ADDENDUM NO. 3
to the SVWRF CONTRACT DOCUMENTS for the
2022 Vac-Truck Dump Station Project

February 3, 2022

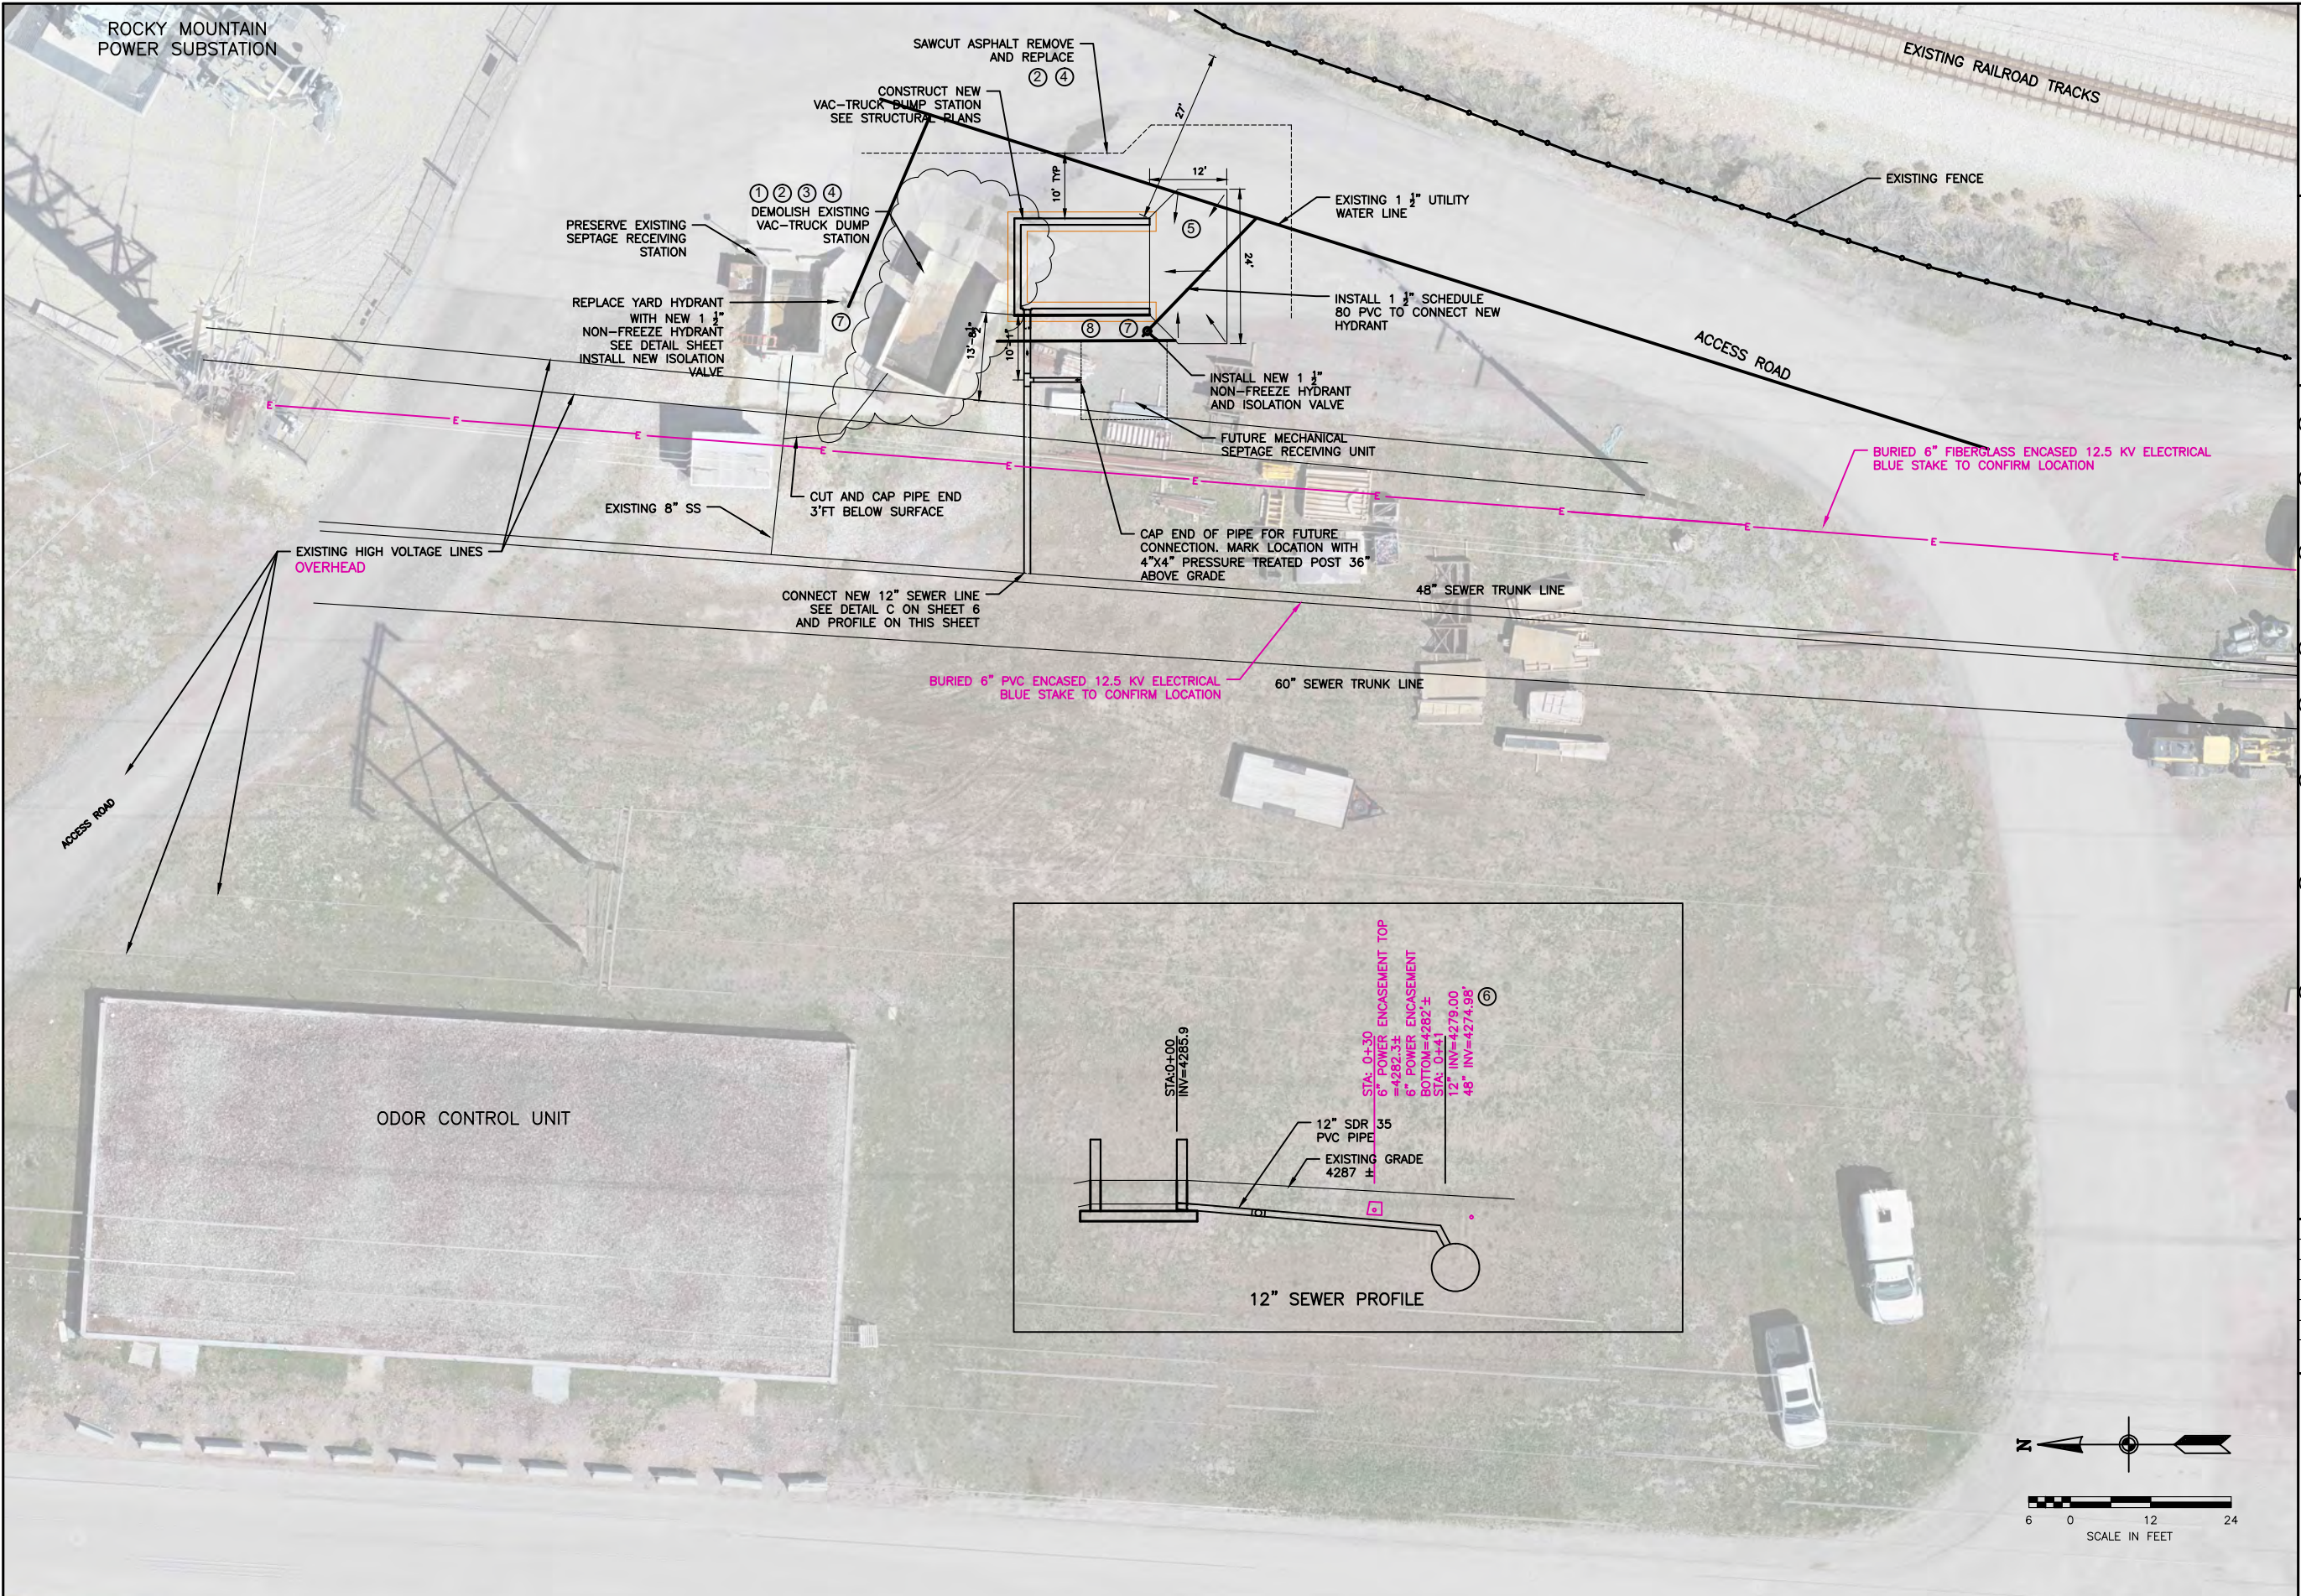
2. The attached utility line information from Rocky Mountain Power is provided for reference. The information was also shown on the updated site plan which is attached.
